Certificate of Appropriateness
BAR #25-0072
300 Court Square, TMP 530096100
Downtown ADC District
Owner: Eagle Tavern, LLC
Applicant: Candace DeLoach; Barry Moss
Project: Portico addition and rear deck

**City of Charlottesville
Board of Architectural Review
Staff Report
April 15, 2025**

Certificate of Appropriateness Application

Project: Exterior alterations, portico addition, rear deck

PHOTO 17 – HISTORIC STEEL SIGN TO BE HUNG WEST OF FRONT ENTRY DOORS

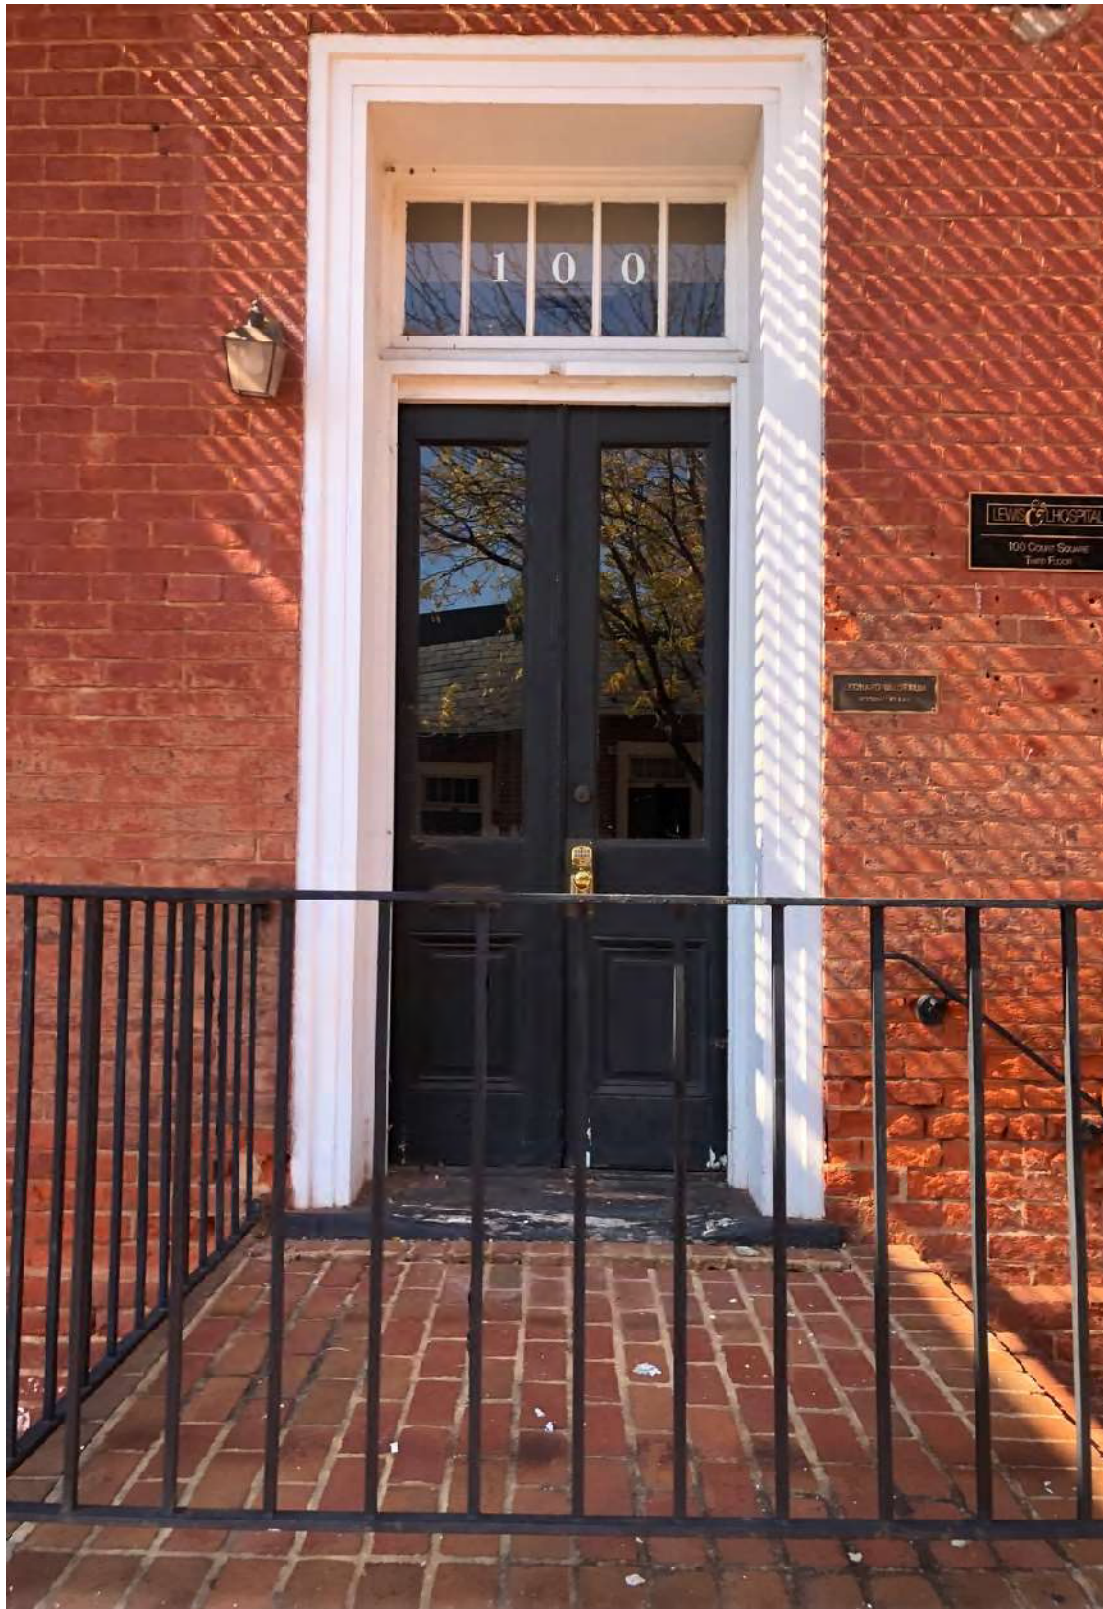
- The proposed flagpoles are omitted.
- The decorative bracket (photo 17) is allowed, provided it meets applicable City requirements. However, all signage will require a separate sign permit(s).

- The proposed flagpoles are omitted.
- The decorative bracket (photo 17) is allowed, provided it meets applicable City requirements. However, all signage will require a separate sign permit(s).

2 SOUTH ELEVATION

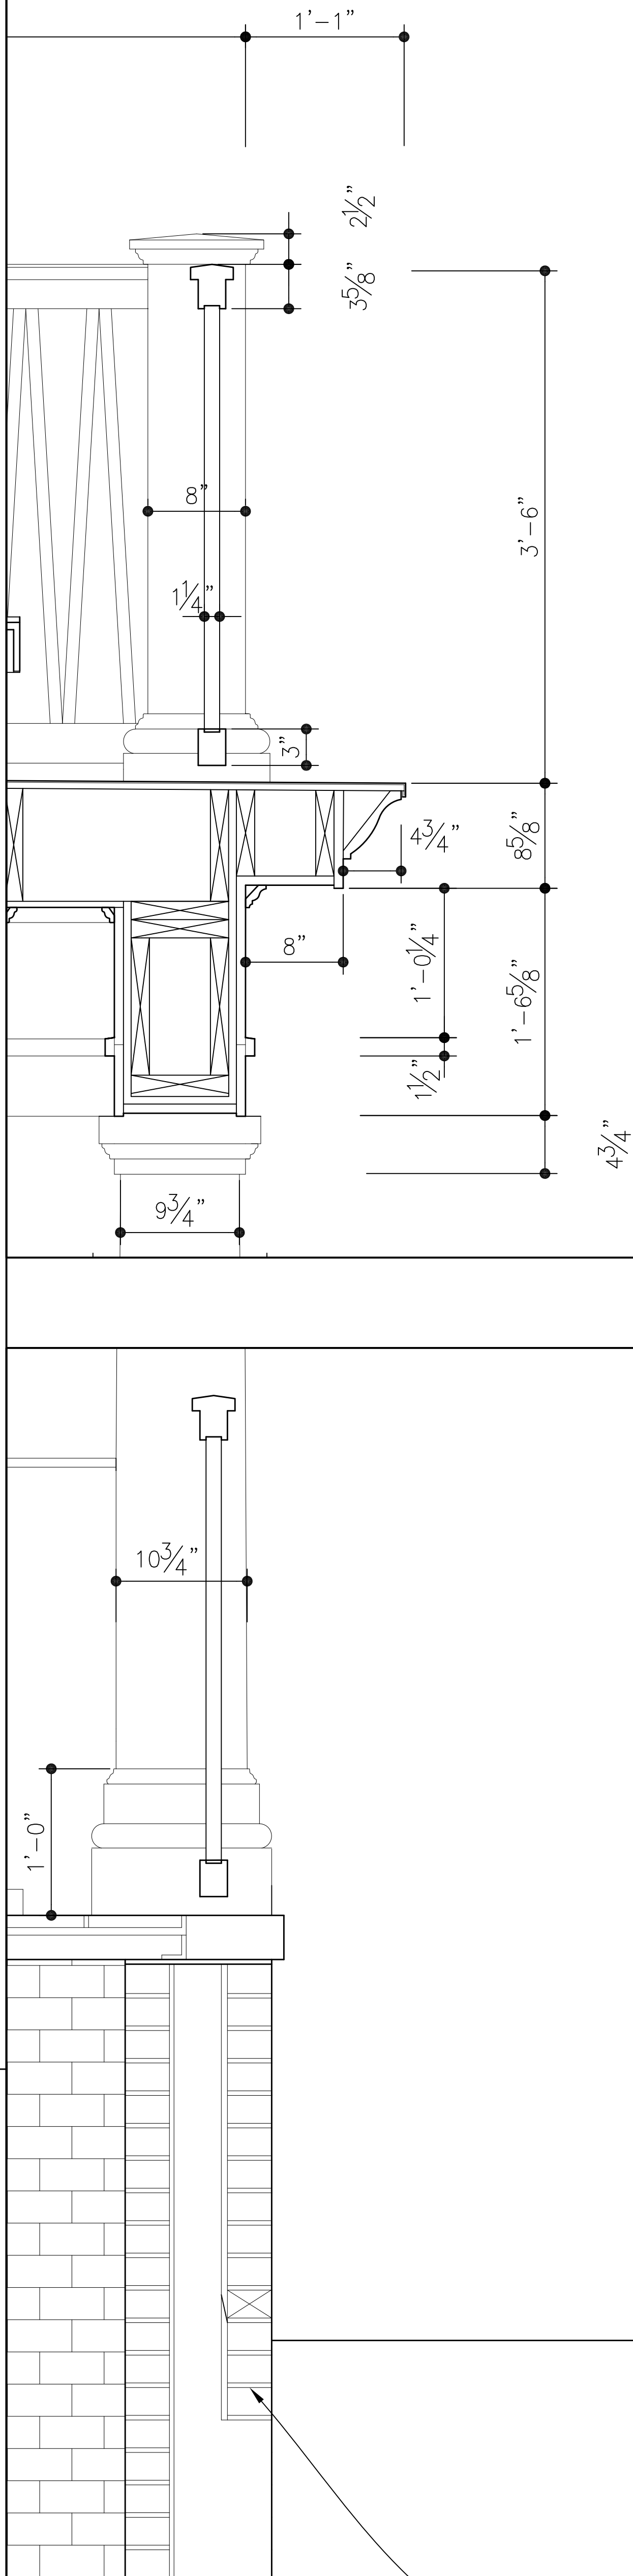
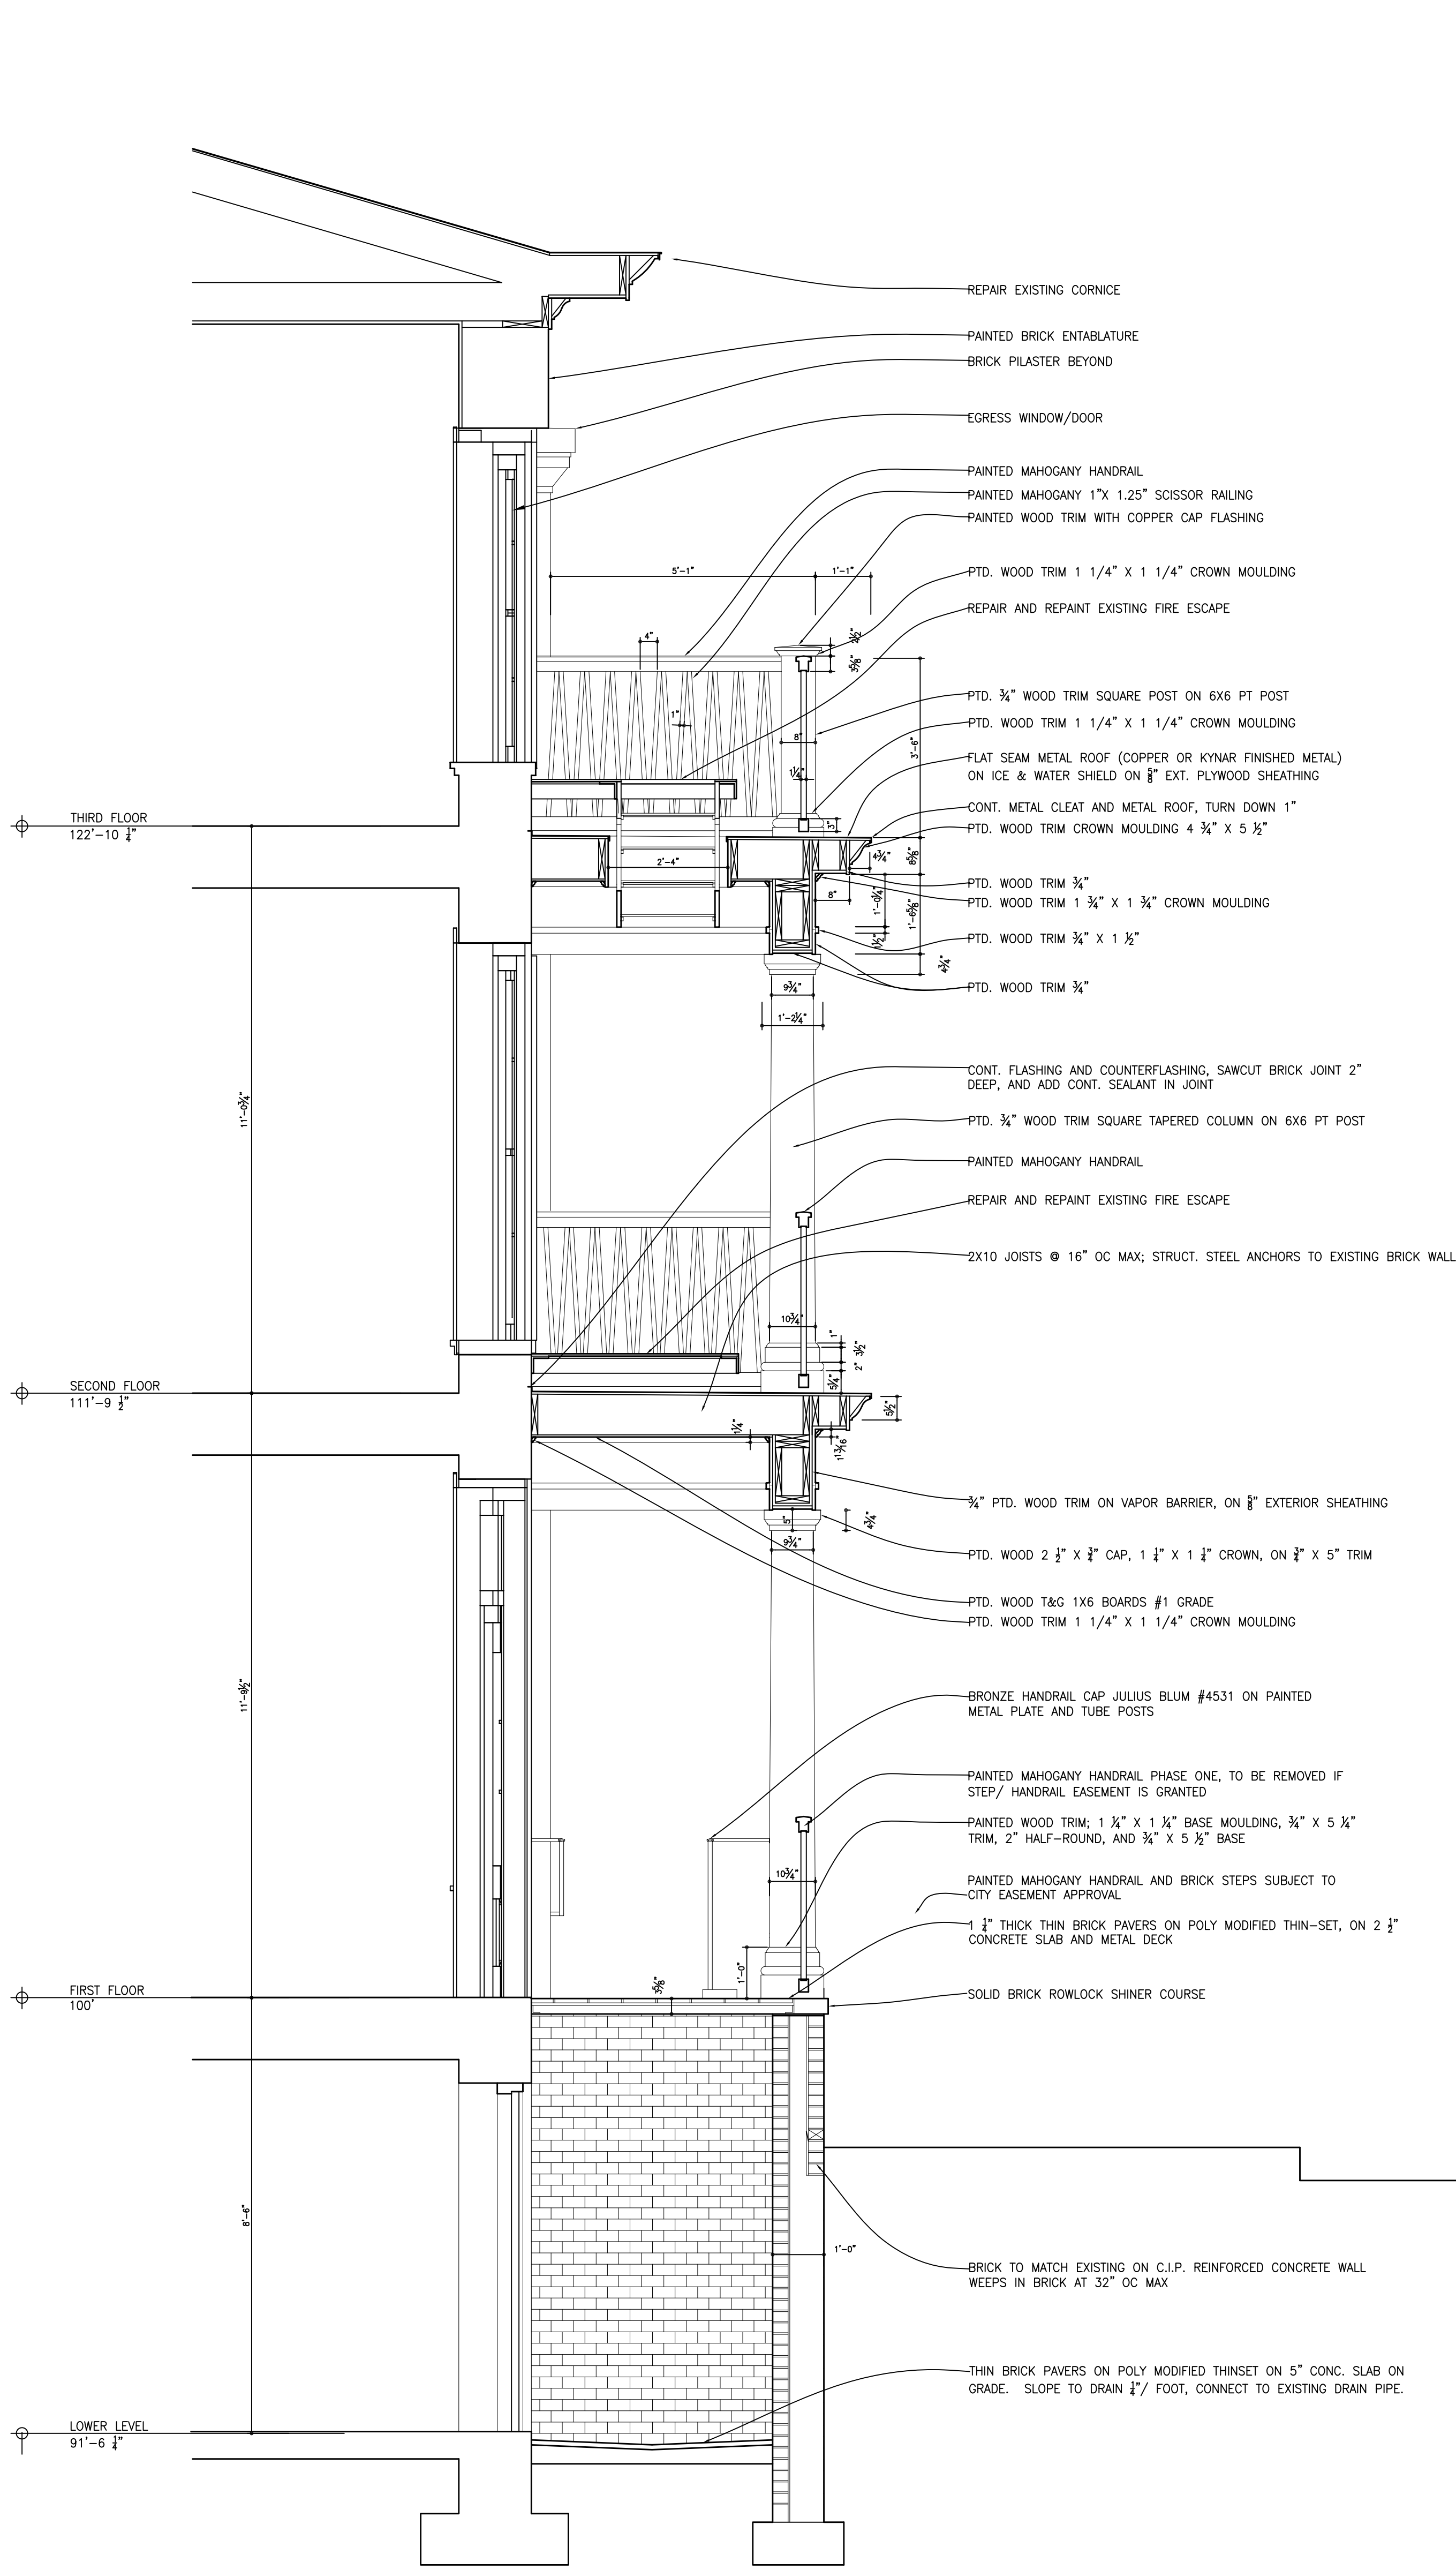
April 2025 CoA request includes Bermuda shutters on the 2nd and 3rd floor windows at the rear of the building, which the BAR approved in 2022. The BAR should include a condition stating these are allowed only on the south elevation of 300

Court Square (the 1854 building) and the west and south elevations of 100 Court Square (the 1880 Annex).

- Mechanical units will be screened per the note approved with the December 20, 2022 CoA. [See Appendix of this staff report.]
- Bermuda shutters on the 2nd and 3rd floor windows at the rear of the building are allowed only on the south elevation of 300 Court Square (the 1854 building) and the west and south elevations of 100 Court Square (the 1880 Annex).

- Mechanical units will be screened per the note approved with the December 20, 2022 CoA. [See Appendix of this staff report.]
- Bermuda shutters on the 2nd and 3rd floor windows at the rear of the building are allowed only on the south elevation of 300 Court Square (the 1854 building) and the west and south elevations of 100 Court Square (the 1880 Annex).
